Appendix A – WSCC Comments

WEST SUSSEX COUNTY COUNCIL CONSULTATION

TO:	Horsham District Council FAO: Matthew Porter
FROM:	WSCC – Highways Authority
DATE:	23 March 2026
LOCATION:	Land North West of Southwater
SUBJECT:	DC/26/0366 Outline planning application, with all matters reserved (except for primary access to the highway) for a phased development comprising: the demolition of existing buildings and the construction of residential dwellings (including affordable housing) (Use Classes C2 and C3); a mixed-use neighbourhood centre (Use Classes E and F); education facilities (Use Class F1(a)); business and employment floorspace (Use Classes B2, B8 and E(g)); redevelopment of existing agricultural buildings including construction of a building for community use (Use Classes E and F2); improvements to public rights of way; sports pitches; gypsy and traveller pitches/plots; public open space; landscaping, and associated infrastructure.
DATE OF SITE VISIT:	As part of pre-application discussions in October 2025

RECOMMENDATION:	More Information

BW3568 (Downs Link, NCN Route 223)

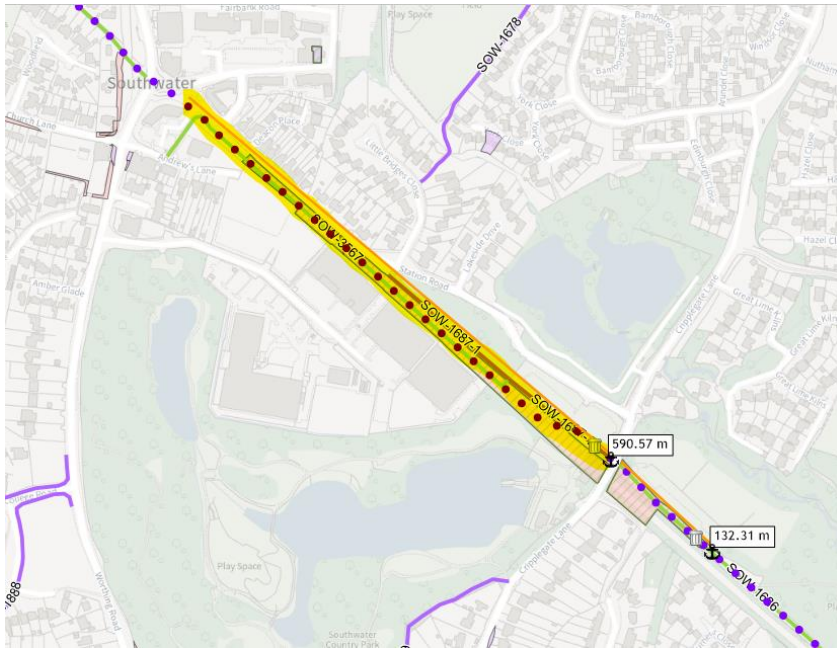
The part of the Downs Link within the proposed site's red line boundary is programmed for drainage and surface improvements by WSCC in the 2026/27 financial year. We would therefore ask that the Downs Link within the site be retained as is and not be improved. My objection is partly on this basis.

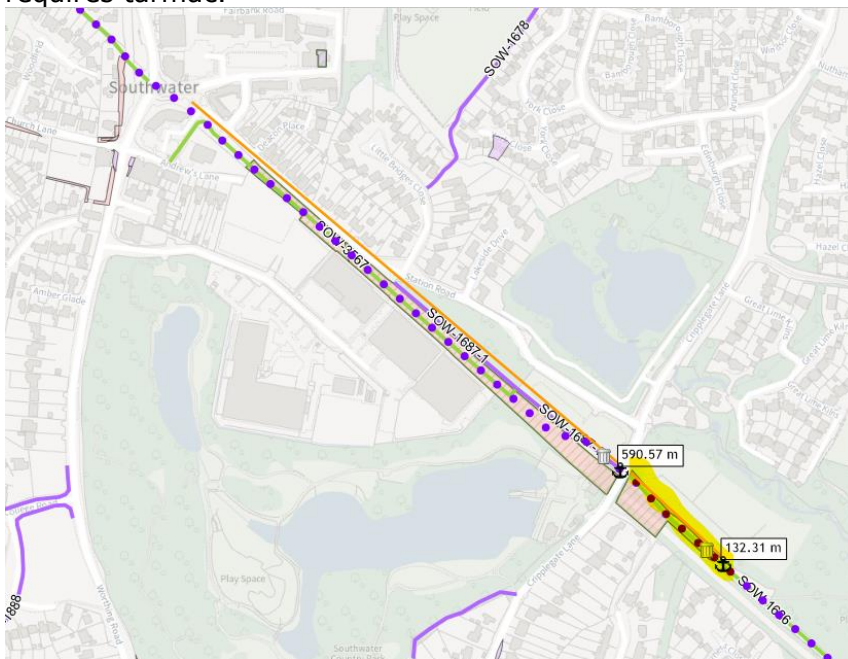
A 590m section (highlighted) between the Southwater Health Centre and Cripplegate Lane would benefit from resurfacing with our standard Type 1 bridleway surfacing.

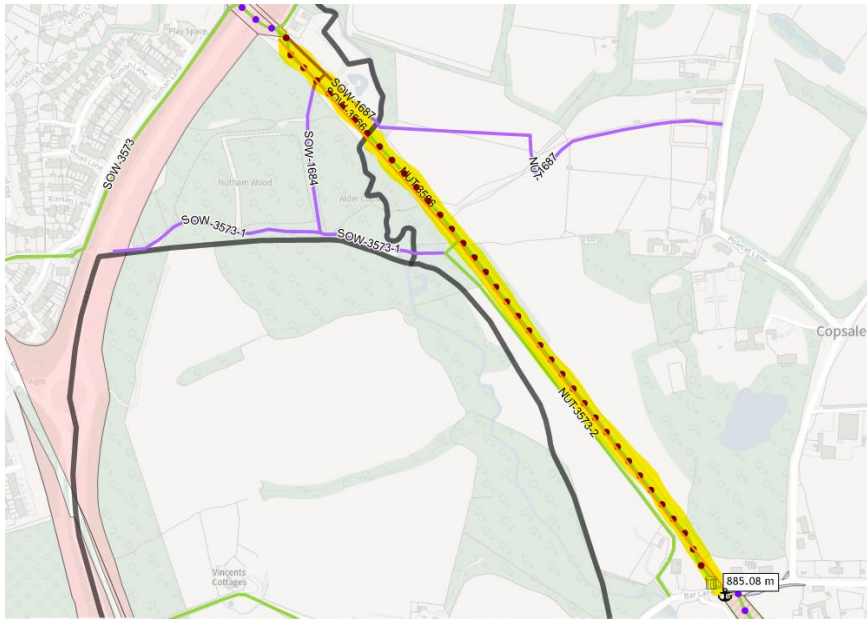
East of Cripplegate Lane, there is a section approximately 132m long (highlighted) that requires tarmac.
